MANDATORY REFERRAL NO. 2024020 – NORTH HIGH STREET EXTENDED

Description

No. MR2024020

Figure 16: Comparison of Existing, Proposed and Ultimate Cross Sections

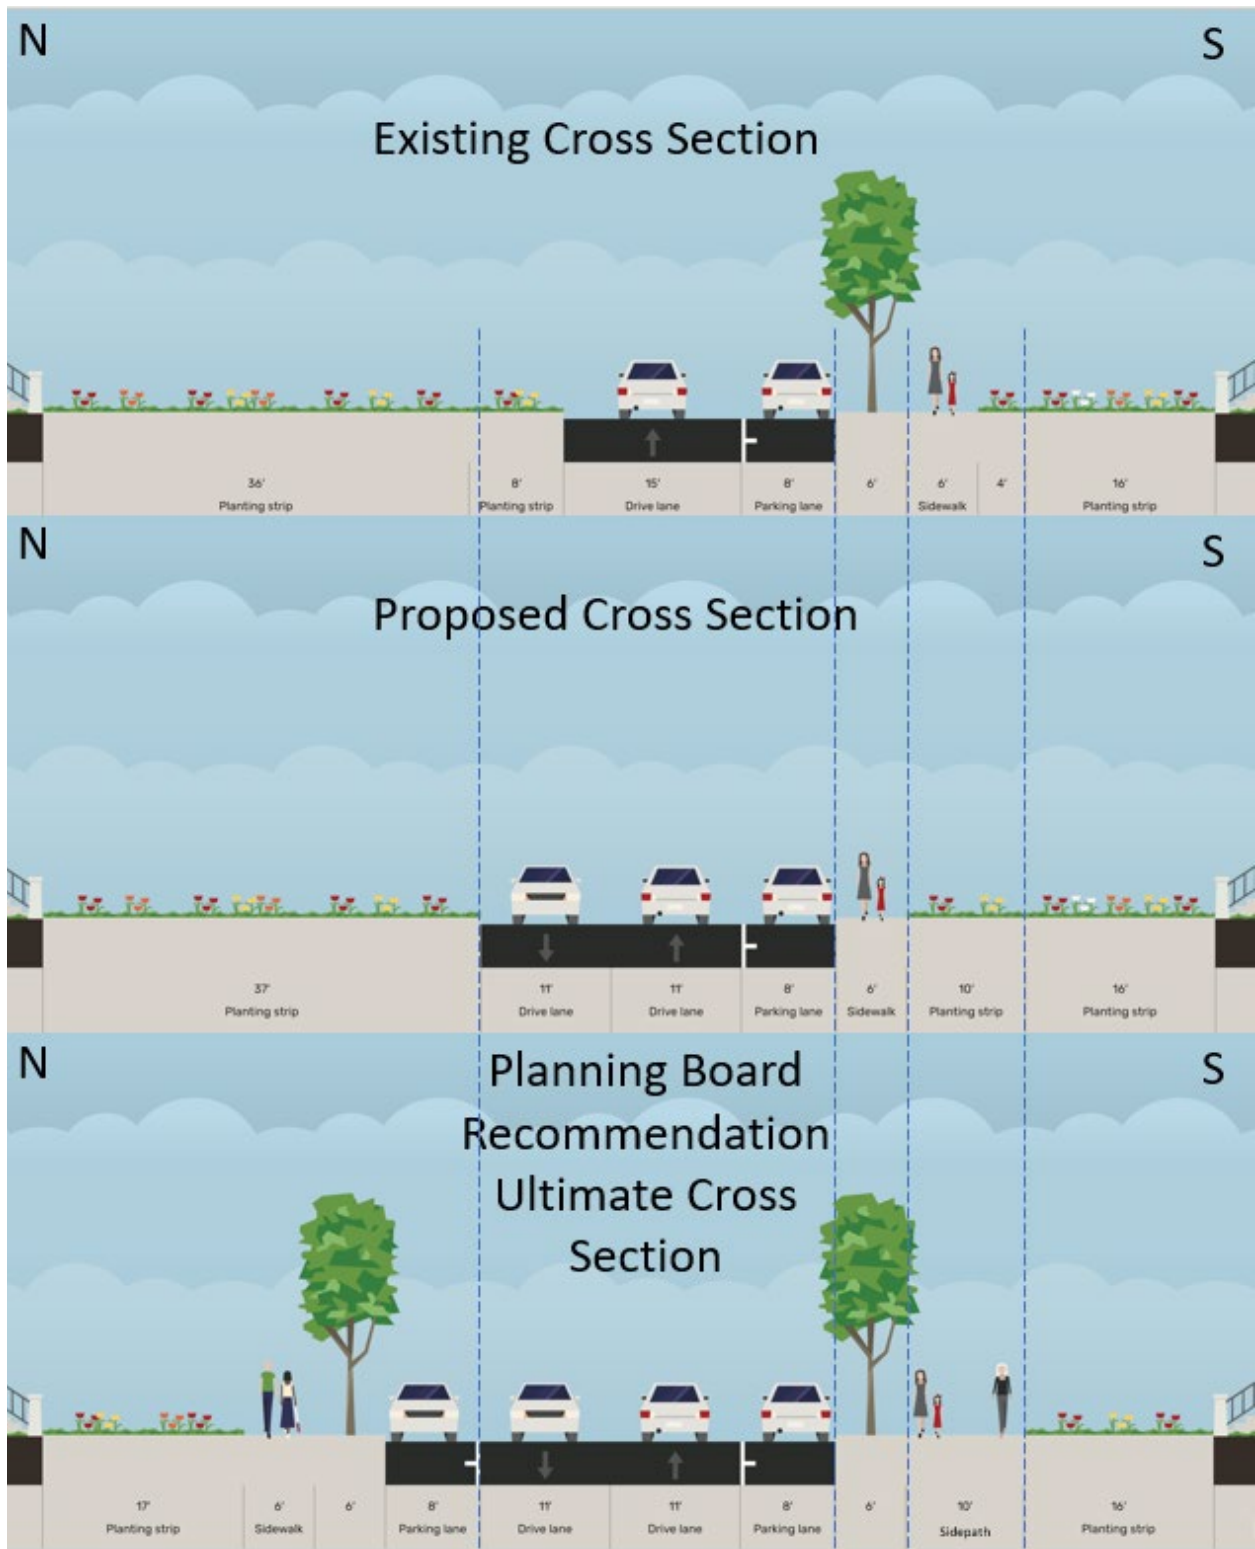
Constructing interim road improvements in the correct ultimate location is critical to ensuring that future street enhancements develop efficiently and cost-effectively. Figure 16 shows how the existing cross section, the proposed cross section and the ultimate typical cross section envisioned by the county’s master plans align. The location of the street and on-street parking along the south or eastbound curb are in a location that aligns with the ultimate cross section. Establishing curb lines is important, as relocating them is costly. In the proposed section, the sidewalk on the south side of the road, however, is not aligned with the ultimate section (six feet) and is not wide enough to accommodate bikes, as recommended by a previous Planning Board. This sidewalk can therefore be considered an interim improvement, and when full right-of-way acquisition is achieved, it will need to be removed in order to construct the ultimate cross section. The Existing Cross Section shown is for the section in front of the Goddard School. The Ultimate Cross Section sidepath (north side) is aligned with the Goddard School sidewalk (it would need to be widened in the future if that sidewalk segment was retained and incorporated into the applicant’s design).

Figure 18: Proposed North High Street/Morningwood Drive Intersection Missing Crosswalk

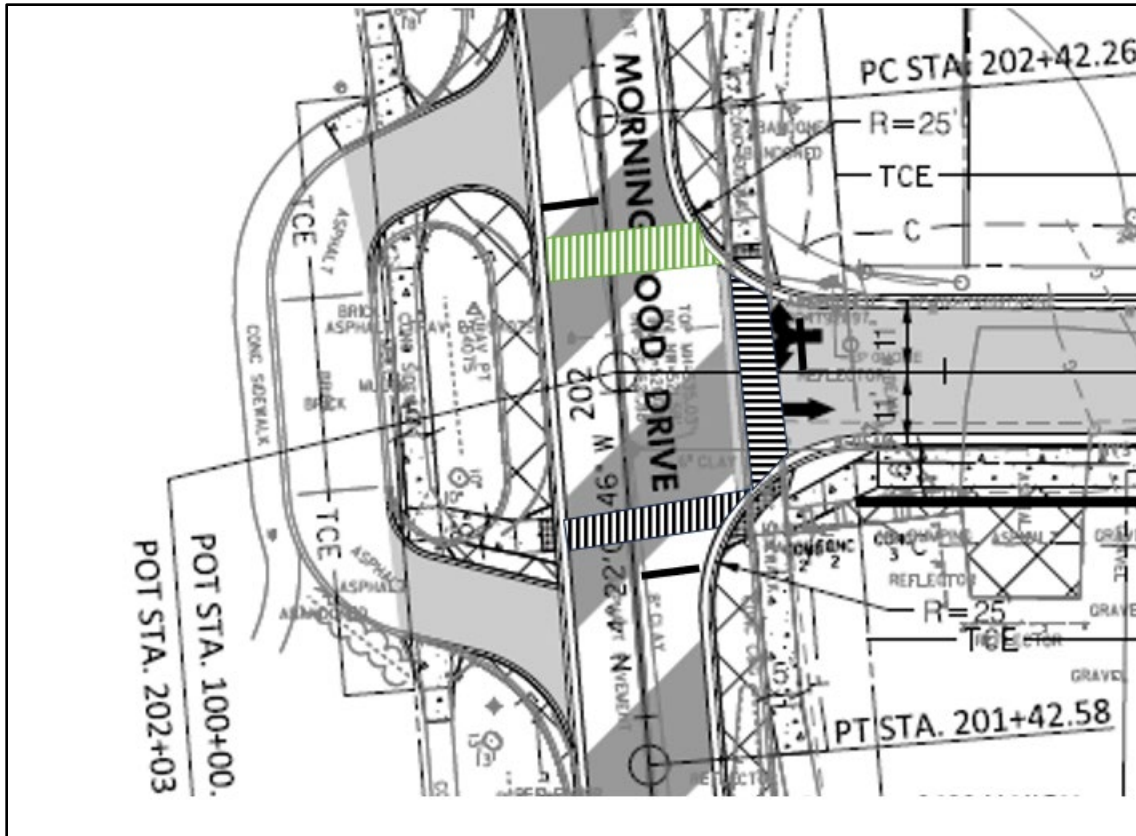
2. **Provide a crosswalk on the north leg of the North High Street and Morningwood Drive intersection with appropriate ADA-accessible curb ramps** (see Figure 18Figure 19). Current practice in Montgomery County is to provide crosswalks on all intersection approaches, whenever possible. This is especially logical, as this intersection will have stop sign control on all three approaches. While the proposed plan has crosswalks on the east and south legs, the crosswalk on the north leg (shown in green shading on the graphic) is missing in the proposed design.

Figure 20: Realign Sidewalk to Cross Driveway at a Perpendicular Angle

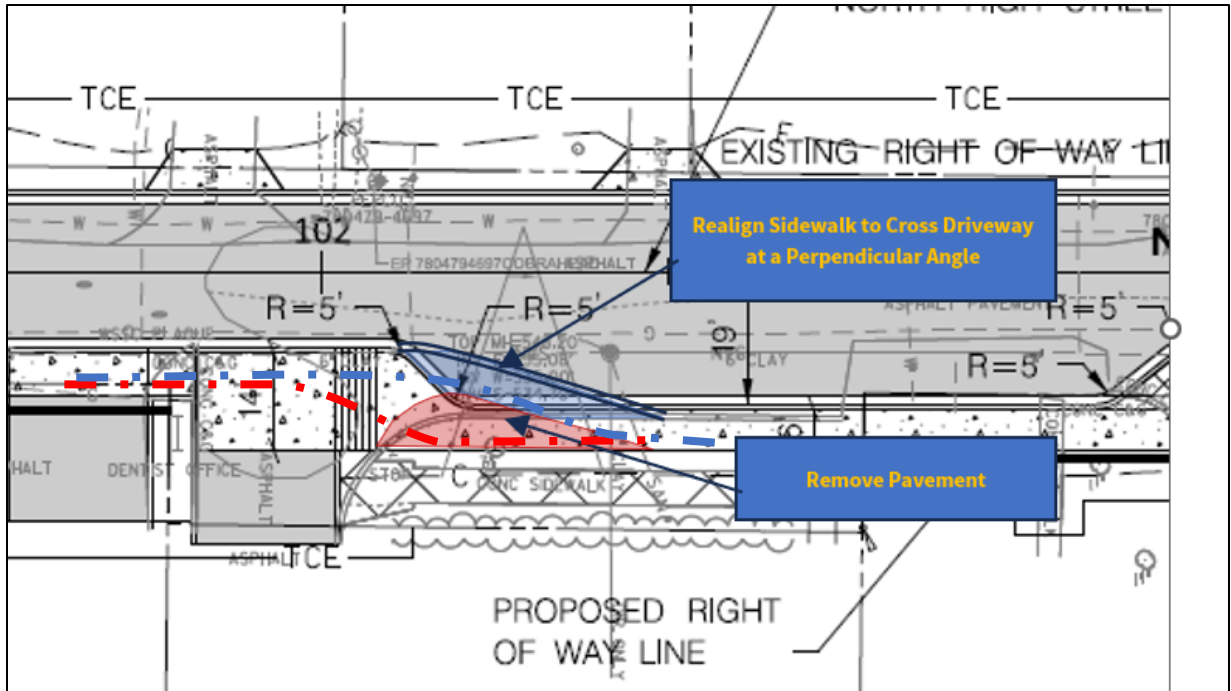
6. **Realign a short section of the proposed sidewalk to cross the alley driveway at a perpendicular angle.** As designed, this sidewalk design does not accommodate pedestrians with vision impairments, as a pedestrian walking westbound wishing to remain on the sidewalk past the driveway must maneuver at an angle within the driveway apron. With a revised design as shown in Figure 20 using the proposed sidewalk design, this sidewalk connection will be significantly enhanced. In this graphic, the dashed red line displays the travel path of a pedestrian which requires a sharp lateral move that coincides with the alley, whereas the dashed blue line displays a shifting of the sidewalk so that the travel path of the pedestrian crossing the alley is perpendicular, simplifying this movement. If the sidewalk design is modified to match the location of the Goddard School sidewalk (consistent with the previous recommendation), a similar sidewalk shift (see Figure 21) will be needed as this issue will likely still remain.

Figure 21: Sidewalk Shift with Goddard School Sidewalk Retained

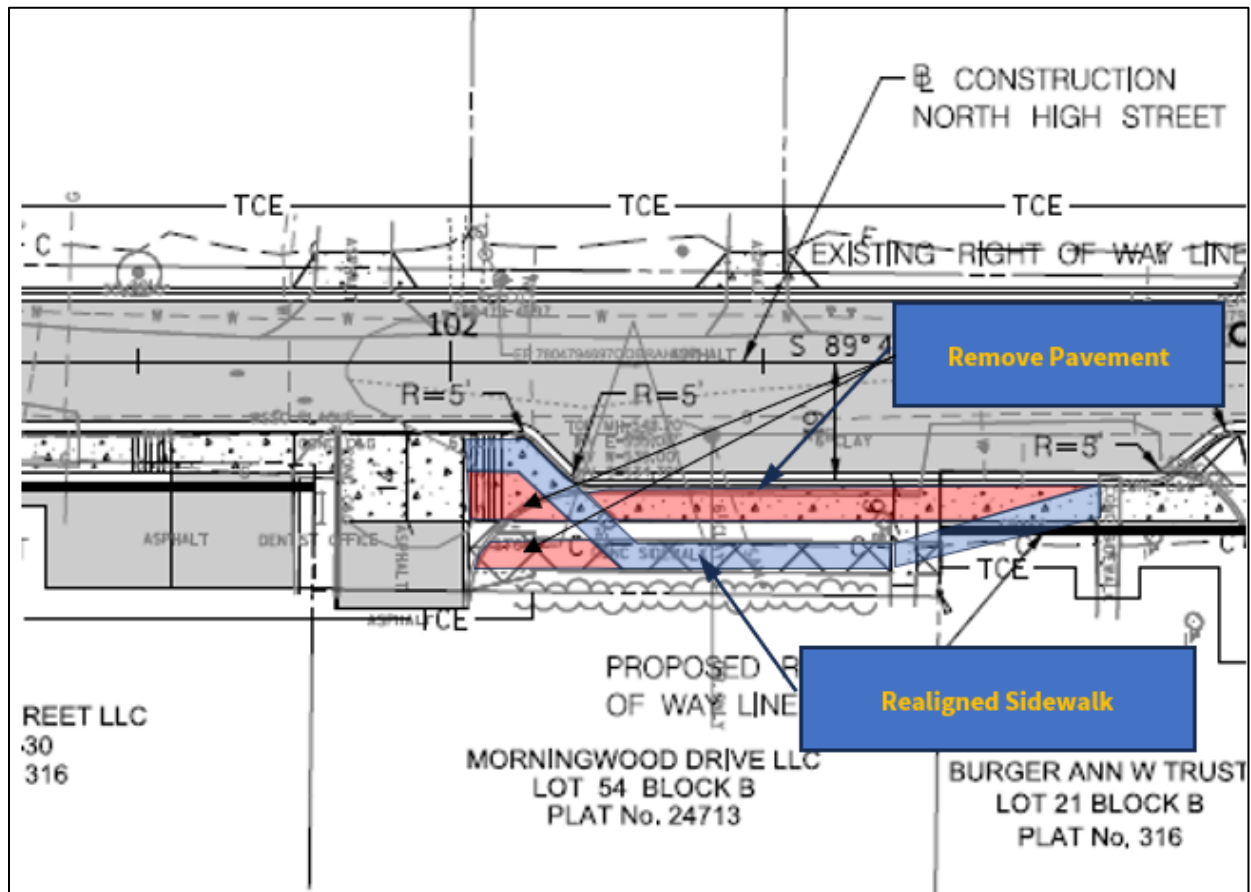
5. **Retain the existing sidewalk alignment on the south side of the road along the Goddard School property and modify the alignment of the proposed sidewalk to connect to it.** The Goddard School sidewalk segment is in the correct ultimate location. Rather than remove this segment as proposed by MCDOT, it would be better to retain the Goddard School sidewalk in its current location.
